Project	<b>IEEE 802.16 Broadband Wireless Access Working Group</b> < <a href="http://ieee802.org/16">http://ieee802.org/16</a> >	
Title	<b>Proposal on change in ARQ</b>	
Date Submitted	<b>2003-08-31</b>	
Source(s)	Vladimir Yanover Tal Kaitz Naftali Chayat Marianna Goldhammer Lei Wang Ofel Kelman Radu Selea Robert Nelson Roger Eline Baraa Al Dabagh	Alvarion <a href="mailto:vladimir.yanover@alvarion.com">mailto:vladimir.yanover@alvarion.com</a> Alvarion <a href="mailto:tal.kaitz@alvarion.com">tal.kaitz@alvarion.com</a> Alvarion <a href="mailto:naftali.chayat@alvarion.com">naftali.chayat@alvarion.com</a> Alvarion <a href="mailto:marianna.goldhammer@alvarion.com">marianna.goldhammer@alvarion.com</a> Wi-Lan <a href="mailto:LeiW@Wi-LAN.com">LeiW@Wi-LAN.com</a> Airspan <a href="mailto:okelman@Airspan.com">okelman@Airspan.com</a> Redline Comm. <a href="mailto:Radu@redlinecommunications.com">Radu@redlinecommunications.com</a> MacPhyModems <a href="mailto:bob_nelson@ieee.org">bob_nelson@ieee.org</a> Intel <a href="mailto:roger.j.eline@intel.com">roger.j.eline@intel.com</a> Intel <a href="mailto:baraa.al.dabagh@intel.com">baraa.al.dabagh@intel.com</a>

Re:	It is a response to IEEE 802.16 Work

Figure NNN.—Block usage examples for ARQ transmissions and retransmissions

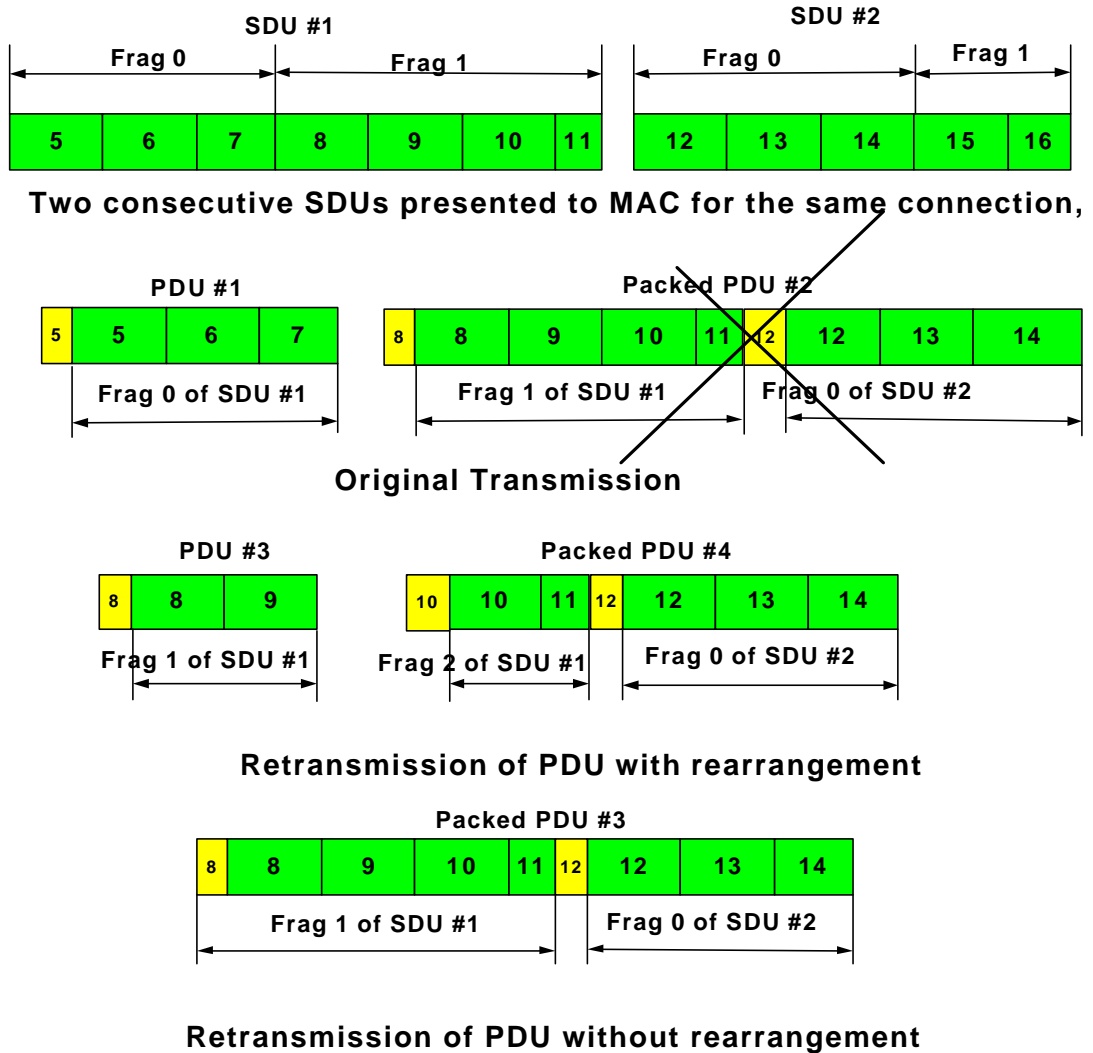
If ARQ is enabled at the connection, Fragmentation and Packing sub-headers contain a BSN, which is the sequence number of the first ARQ block in the sequence of blocks following this sub-header. It is a matter of transmitter's policy whether a set of blocks once transmitted as a single PDU should be retransmitted also as a single PDU or not. Figure NNN illustrates the use of blocks for ARQ transmissions and retransmissions; two options for retransmission presented: with and without rearrangements of blocks.

Figure 31a: Transmitter ARQ state machine

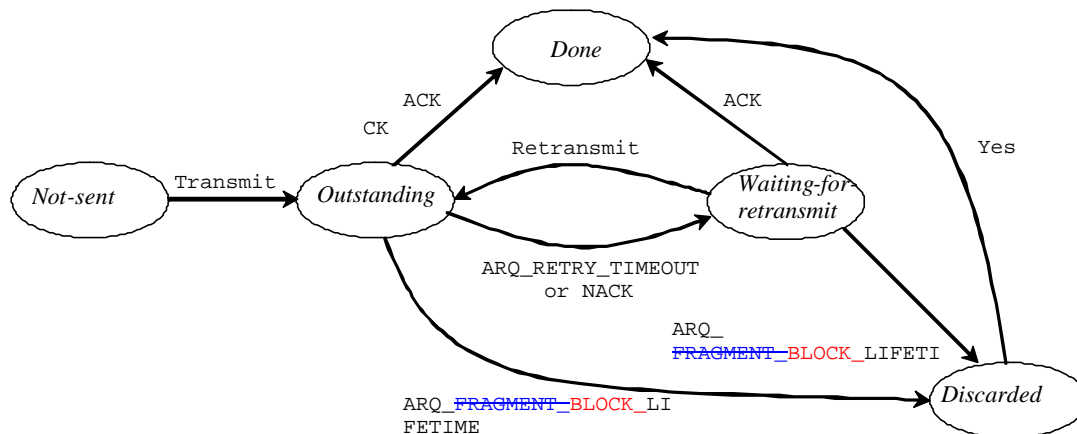
~~The transmitter is responsible for choosing the appropriate fragment size on a per-fragment basis. Determining fragment size is outside the scope of this standard. Unlike non-ARQ connections, where a single MAC PDU would not normally have two consecutive fragments from the same MAC SDU, this is likely for ARQ-enabled connections, since such fragmentation can facilitate retransmission. The MAC-SDU fragment structure shall be maintained for retransmissions~~ An ARQ ~~fragment~~ block may be in one of the following four states, not-sent, outstanding, discarded and waiting-for-retransmission. Any ARQ ~~fragment~~ block begins as not-sent. After it is sent it becomes outstanding for a

period of time termed ACK\_RETRY\_TIMEOUT. While a **fragment block** is in outstanding state, it either is acknowledged and discarded, or transitions to waiting-for-retransmission after ACK\_RETRY\_TIMEOUT or NACK. An ARQ **fragment block** can become waiting-for-retransmission before the ACK\_RETRY\_TIMEOUT period expires if it is negatively acknowledged. An ARQ **fragment block** may also change from waiting-for-retransmission to discarded when an ACK message for it is received or after a timeout ARQ\_FRAGMENT\_LIFETIME. For a given connection the transmitter shall first handle (transmit or discard) **fragment block** in 'waiting-for-retransmission' state and only then **fragment block** in 'non-sent' state. **Fragments Blocks** in 'outstanding' or 'discarded' state shall not be transmitted. When **fragments blocks** are retransmitted, the fragment with the lowest **FSN BSN** shall be retransmitted first. The ARQ transmit **fragment block** state sequence is shown in Figure 31a.

**Figure 31d - ARQ fragment block reception**

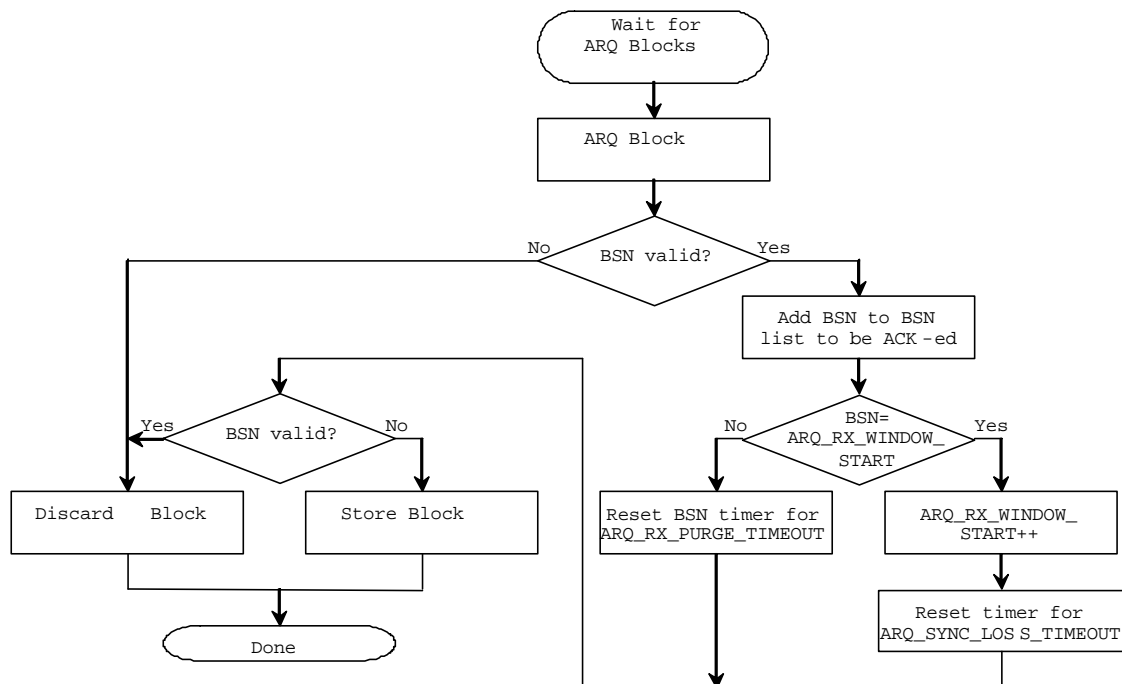
When a PDU is received, its integrity is determined based on the CRC-32 checksum. If a PDU passes the checksum, it is unpacked and de-fragmented, if necessary. The receiver maintains a sliding-window defined by ARQ\_RX\_WINDOW\_START state variable and the ARQ\_WINDOW\_SIZE parameter. When an ARQ fragment block with a number that falls in the range defined by the sliding window is received, the receiver shall accept it. ARQ fragment block numbers outside the sliding window shall be rejected as out of order. The

receiver should discard duplicate ARQ **fragments blocks** (i.e. ARQ **fragments blocks** that were already received correctly) within the window.
